3 REVISION 3 RESCINDS REVISION 2

CONTRACT CHANGE ORDER NO. ____
SHEET ____ OF ____

SAN FRANCISCO OAKLAND BAY BRIDGE
EAST SPAN SEISMIC SAFETY PROJECT
SELF-ANCHORED SUSPENSION BRIDGE
(SUPERSTRUCTURE & TOWER)

SUSPENDER LAYOUT NO. 2

Chart A: DL Moment Corresponding to suspender forces shown in suspender Schedule (Eastbound shown, Westbound similar)

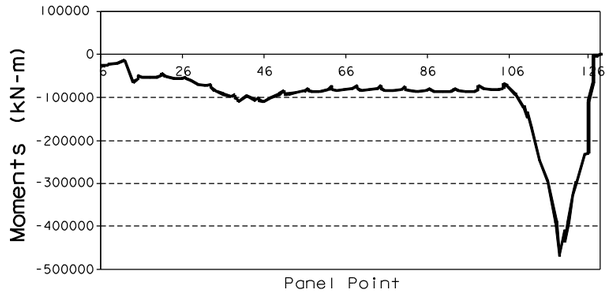
MARK	DATE	DESCRIPTIONS	BY	CH'D	CCO#
3	06/10/09	SUSPENDER LOADS	GB	MN	56
2	10/31/08	SUSPENDER LOADS	GB	MN	56
1	04/16/07	CABLE SYSTEM	GB	MN	37
